Number F.1.
 Section Gearbox and
 Overdrive
 Sheet 1 (of 1)
 Date October, 1961

GEARBOX CONSTANT PINION OIL SEAL

Number F.7.

STICKING IN 1ST GEAR.~~(All synchromesh gearbox models)~~

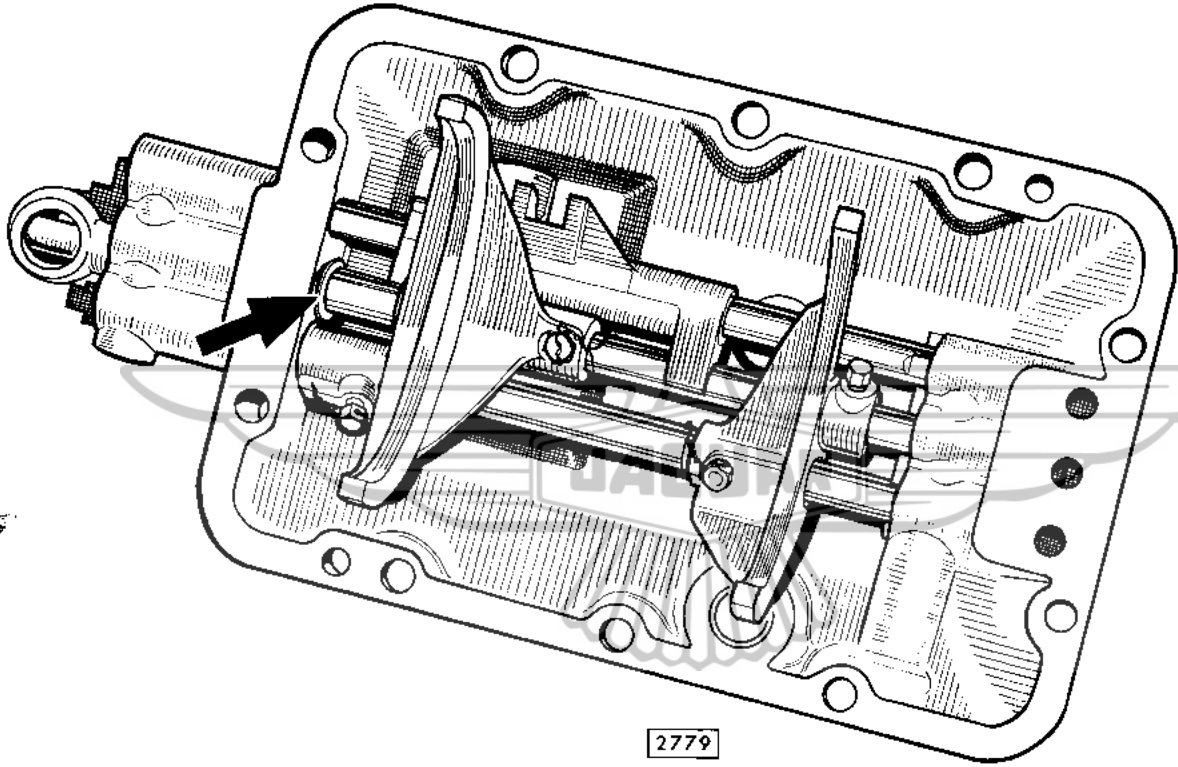
If difficulty is experienced with sticking in first gear the following procedure should be adopted.

Remove the console trim and gearbox tunnel cover, then the top cover of the gearbox. It may then be necessary to use two levers to ease the 1st speed gear forward on the 2nd speed synchro-sleeve. Ignore the slight damage which may have occurred to the stop pin on the 2nd speed synchro-sleeve.

With the gearbox top cover on the bench, remove the selector housing by taking off the four retaining nuts. This will expose the three plunger springs which should be removed together with the plunger and balls (and shims if any). Withdraw the centre welch washer at each end of the top cover by piercing and prising as necessary. Then remove the wired dowel pins retaining the stop and the change speed fork on the centre striking rod so that this may be driven forward a sufficient amount to fit a washer $\frac{3}{4}$ " (19 mm) outside diameter and $\frac{1}{2}$ " (12.7 mm) inner diameter, thickness $\frac{1}{16}$ " (1.6 mm) onto the rod behind the change speed fork. Ensure that the washer clears the selectors on the other striking rods. (See illustration overleaf).

Replace the striking rod, change speed fork and stop and refit the two dowel pins wiring them up as before. Fit new welch washers either end of the top cover then replace the three balls, plungers, springs and shims (if fitted) in the respective holes. Use a new gasket when replacing the selector housing and fit a new gasket on the gearbox case top face. Place the gearbox in neutral offer up the top cover noting that it is located by two dowels and secure in position with the ten setscrews and spring washers (two long screws at rear and two short screws at front). Replace the tunnel cover and trim.
